ADDENDUM

ADDENDUM NO.: 02
PROJECT NAME: Sherman Park Branch Library – Repairs and Renovations
PROJECT NO.: 08325
CONTRACT NO.: C1630
DATE OF ISSUE: July 28, 2026

NOTICE OF CHANGES, MODIFICATIONS, OR CLARIFICATIONS TO CONTRACT DOCUMENTS

A7.01

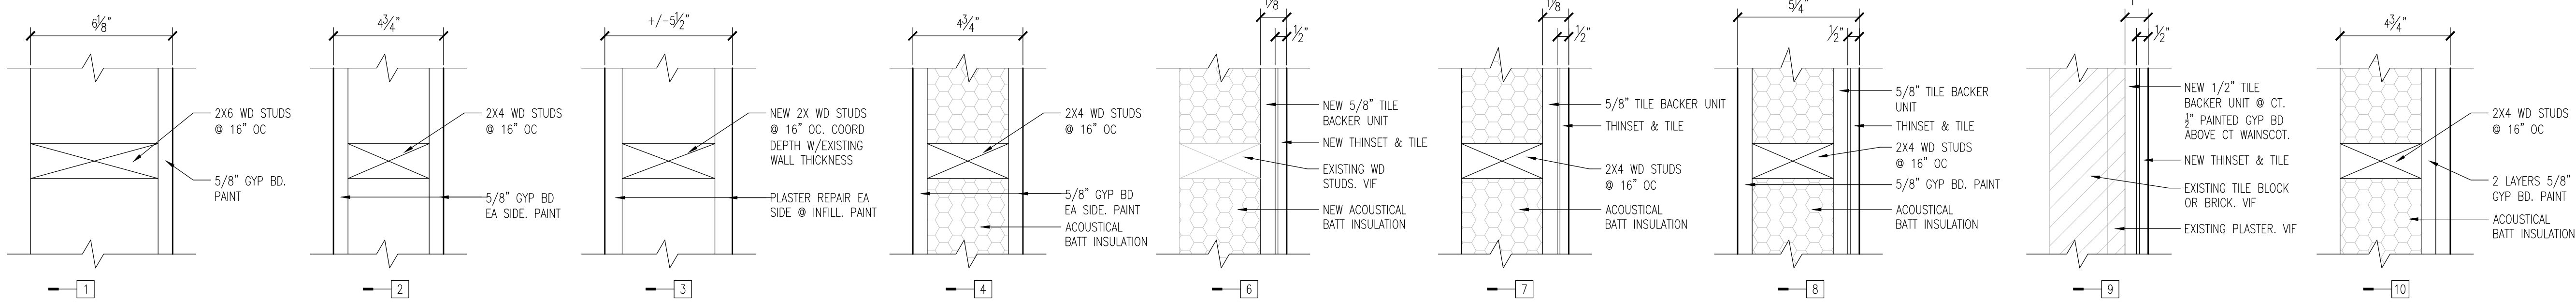
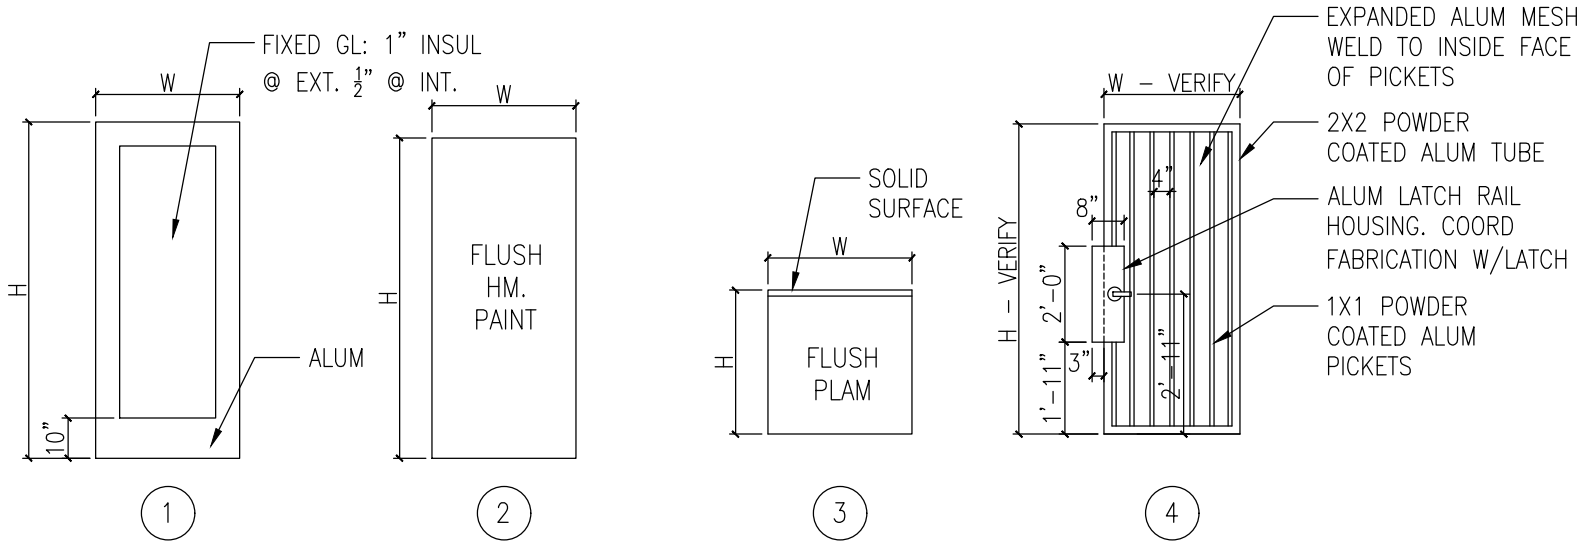
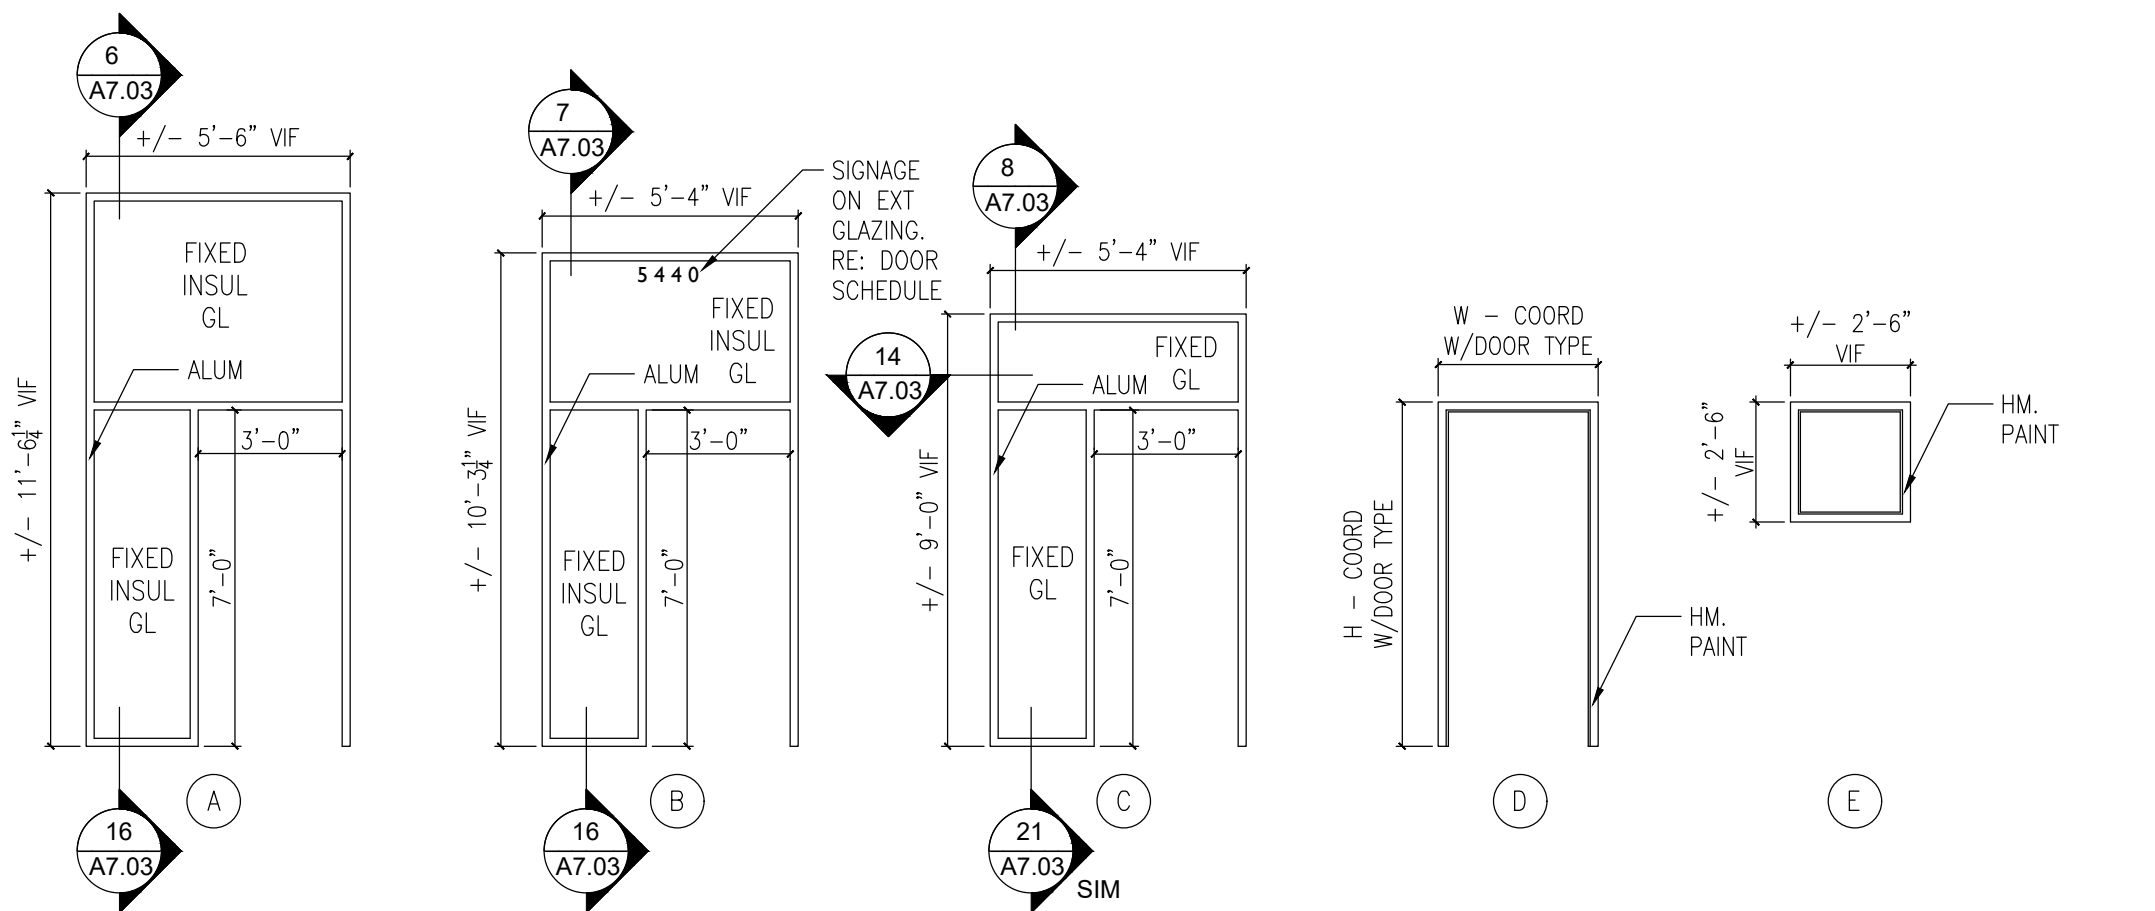
Change 1 REVISED Drawing 1/A7.01: Added wall type note to clarify existing deck heights.

Question: Reference A7.01 partition schedule. Please provide deck heights for new wall framing and drywall.

Response: Please refer to Detail Note number 1 Wall Types on revised drawing sheet A7.01 included in this addendum. Deck heights are anticipated per below specifications and shall be verified in the field.
- Basement Level Deck Height – 9'-5"
- First Floor Deck Height – 14'-0"

WALL TYPE NOTES:
1. FULL HEIGHT PARTITIONS EXTEND TO DECK ABOVE:
A. BASEMENT LEVEL: EXST CONC DECK +/-9'-5" AFF. VIF.
B. FIRST FLOOR LEVEL: EXST WOOD DECK +/-14'-0" AFF. VIF.

P0.01

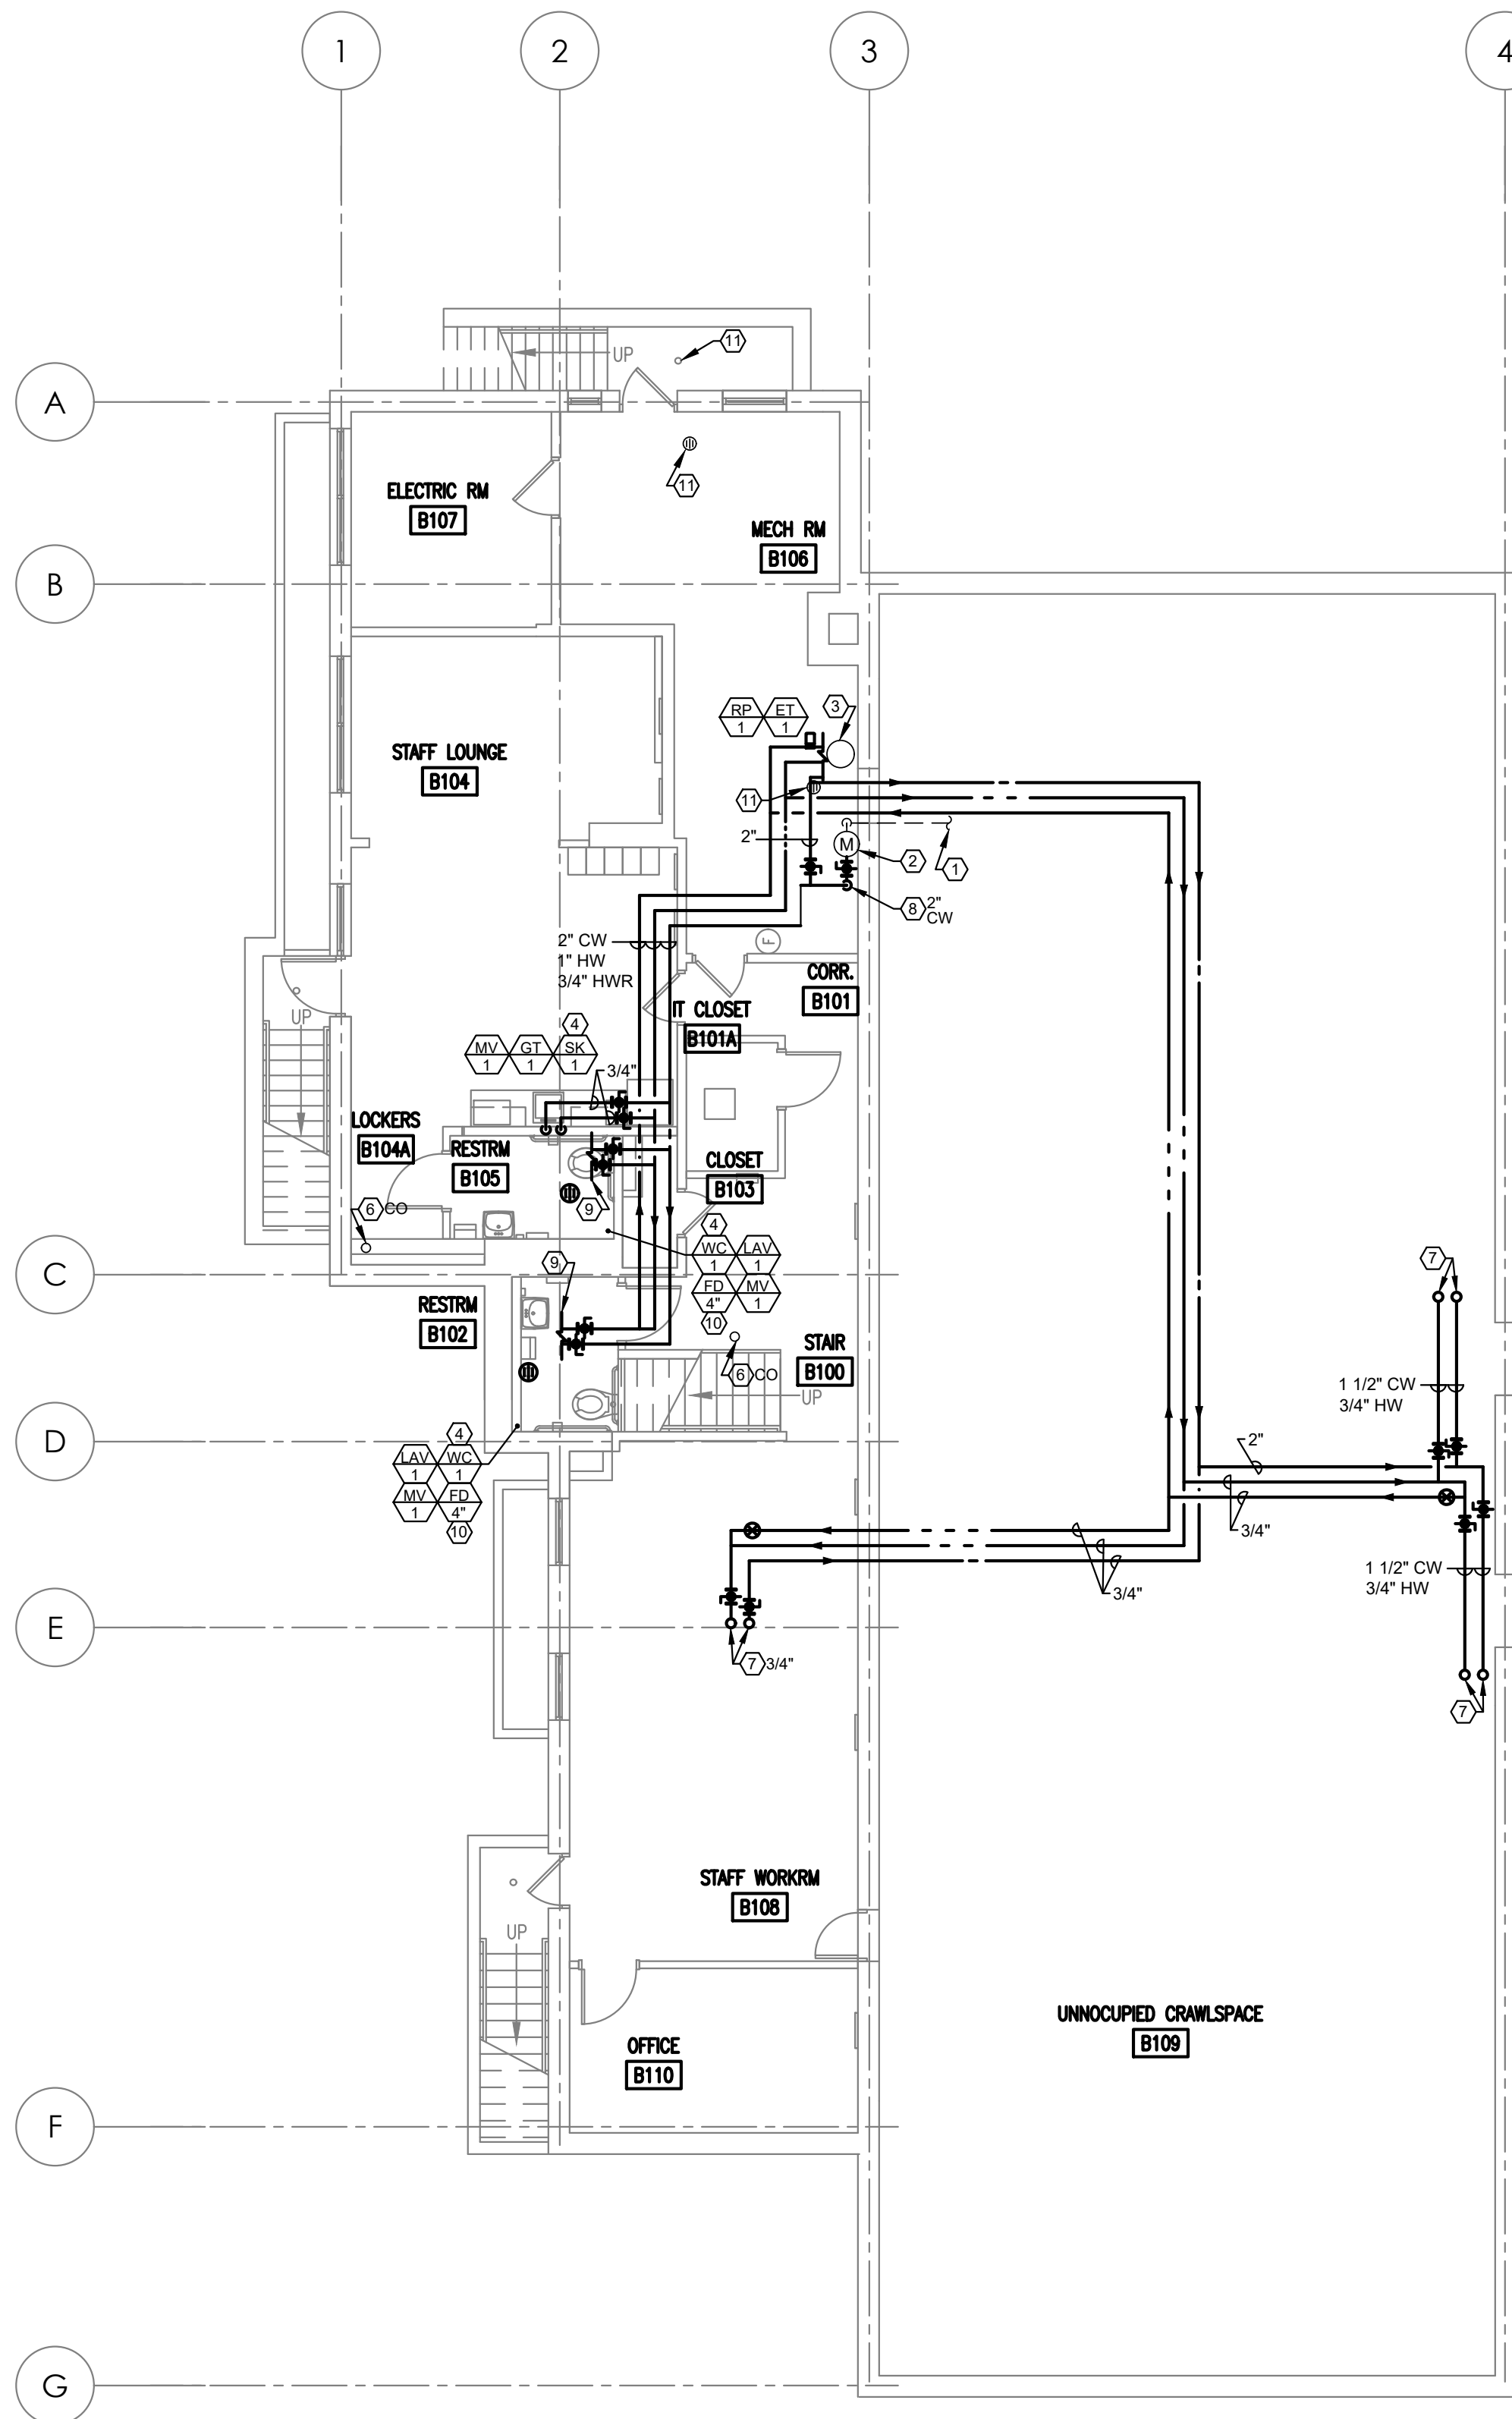
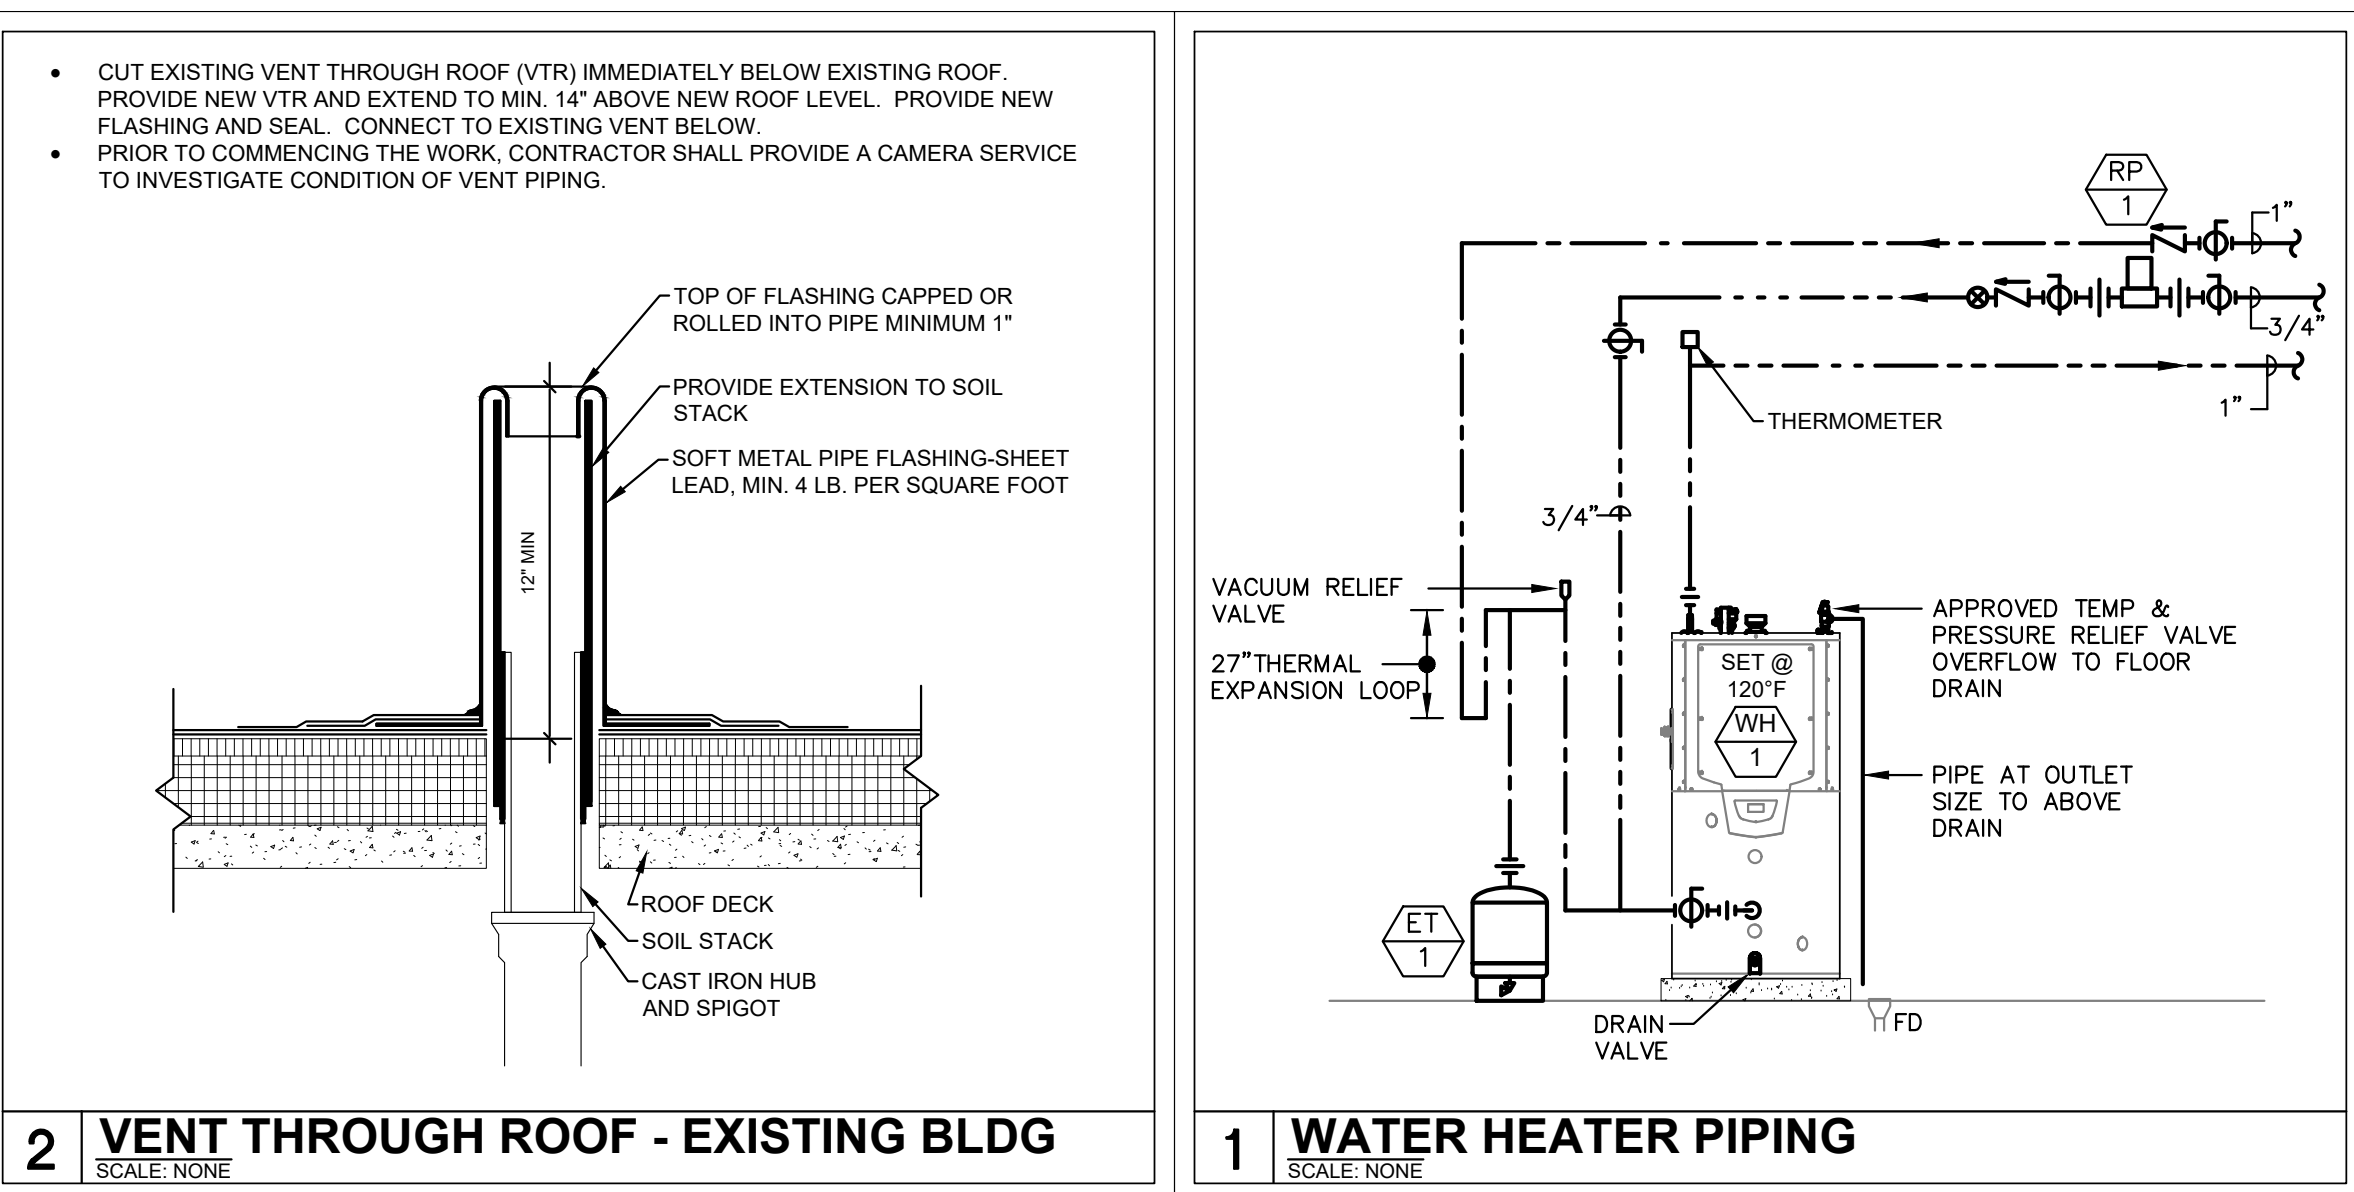
Change 3 REVISED General Plumbing Notes P0.01: Deleted note numbers one and three. note number six.

1. NOT USED.
2. THIS CONTRACTOR SHALL FURNISH, INSTALL AND CONNECT ALL EQUIPMENT IN ACCORDANCE WITH THE CHICAGO BUILDING CODE. AFTER EACH WORK DAY, CONTRACTOR SHALL CLEAN ALL WORK AREAS AND REMOVE ALL DEBRIS.

3. NOT USED.
4. CONTRACTOR SHALL SUBMIT SCALED, LAYOUT DRAWINGS (SHOP DRAWINGS) OF PIPE AND FITTINGS INCLUDING (BUT NOT LIMITED TO) PIPE SIZES, LOCATIONS, ELEVATIONS AND SLOPES OF HORIZONTAL RUNS, WALL AND FLOOR PENETRATIONS AND CONNECTIONS. IN ADDITION, ALL PLUMBING DRAWINGS SHALL SHOW THE INTERFACE AND SPATIAL RELATIONSHIPS BETWEEN PIPING AND APPROXIMATE EQUIPMENT.
